WORKPLAN ADDENDUM

An Updated Site Conceptual Model, and A Revised Soil & Groundwater Investigation Workplan

Former Durham Transportation Facility
Alameda County Fuel Leak Case No. R00000047
19984 Meekland Avenue
Hayward, Alameda County

January 27, 2005

FIGURE 2 Job# H9042

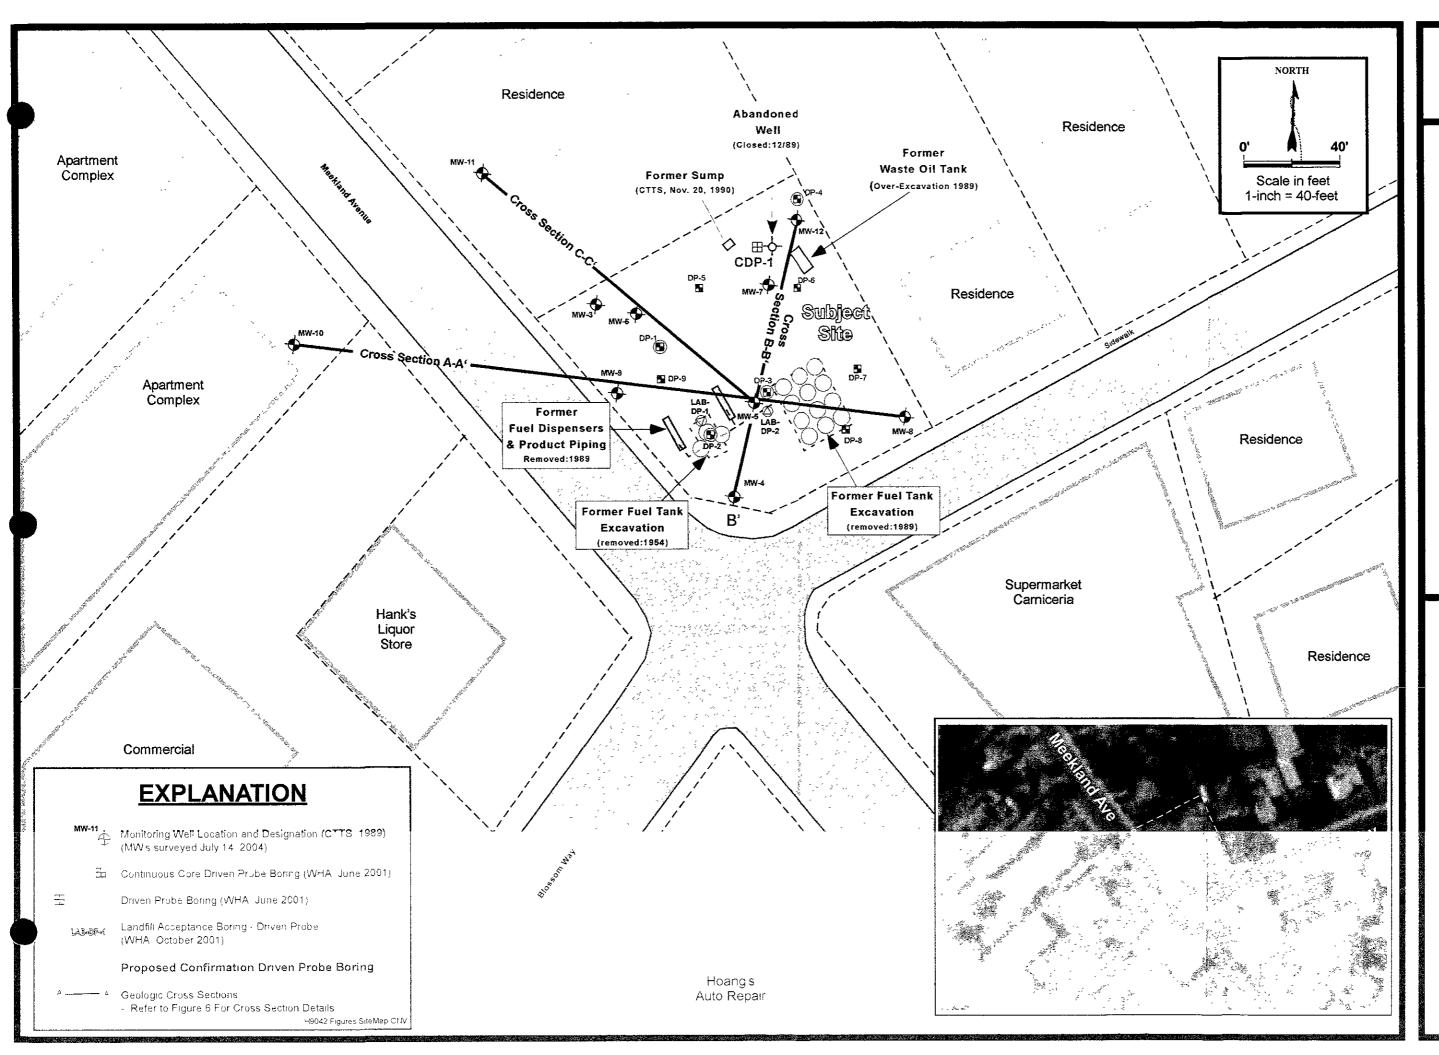
ACEH Comment #3 - Site Map: We reiterate our May 13, 2004, request that you prepare a revised map of the site and downgradient area. Toward this request. Task 4 in Weber, Hayes' July 30, 2004 workplan is acceptable as proposed; however, additional work is necessary to fully respond to our request. In addition to surveying monitoring well locations, our May 13, 2004, letter requested that you map additional structures in the site vicinity. Your revised map needs to include the former fuel island and LUST piping locations, offsite buildings, and other structures to help clearly identify the physical location of your plume and its potential impacts. In meeting this requirement, we suggest that you accordingly revise Figure 2 in both Weber, Hayes' workplan and SCM provided that this figure is to scale and that additional area north and west of the subject site shown. Please prepare the revised site map, update your SCM as necessary, and report your findings in the workplan addendum requested below.

#3 Response: As requested, changes have been made to the site map including identification of product pipe locations and off-site structures (see Figure 2). The site was re-surveyed in 2004 and the well locations and elevations have been confirmed (see Figure 8).
